MEMORANDUM

Date: September 29, 2008

Subject: UPDATED DRAFT CODES AND DRAFT MASTER PLAN AND DESIGN GUIDELINES FOR PARKPLACE PRIVATE AMENDMENT REQUEST, FILE NO. ZON07-00016

Master Plan and
Design Guidelines
DRAFT September 29, 2008

CBD 5A Maximum Building Heights

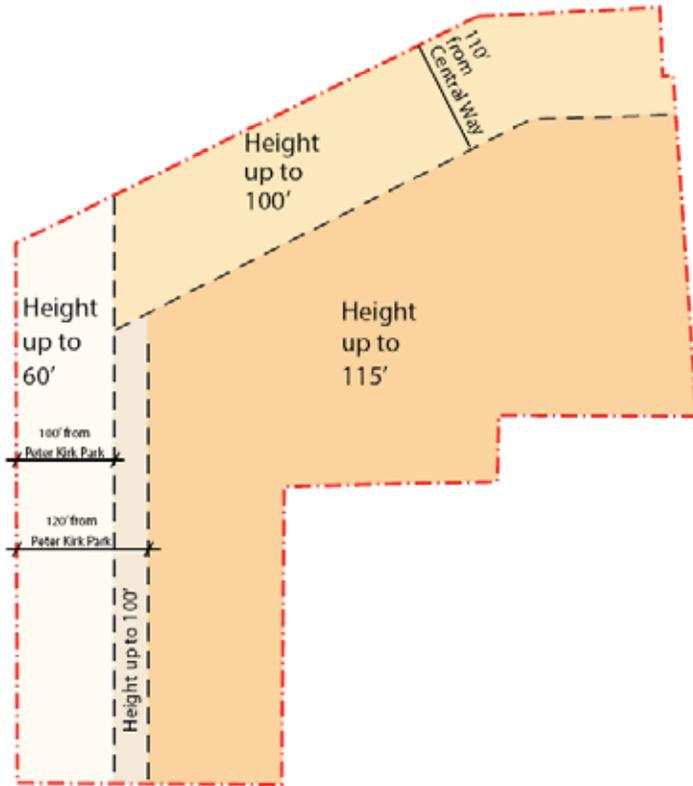
The Planning Commission should confirm allowed building heights for Building E. The building has been represented as a two-story building in recent diagrams. However, the proposed height allowances would allow a building between 60' high on the west side, terracing up to the east to 100' and 115' in height. The diagram below shows proposed height allowances for Building E.

Height of Structures: See Special Regulation 5 and Plate X-2A and X2-B.

Deleted: 115 feet above
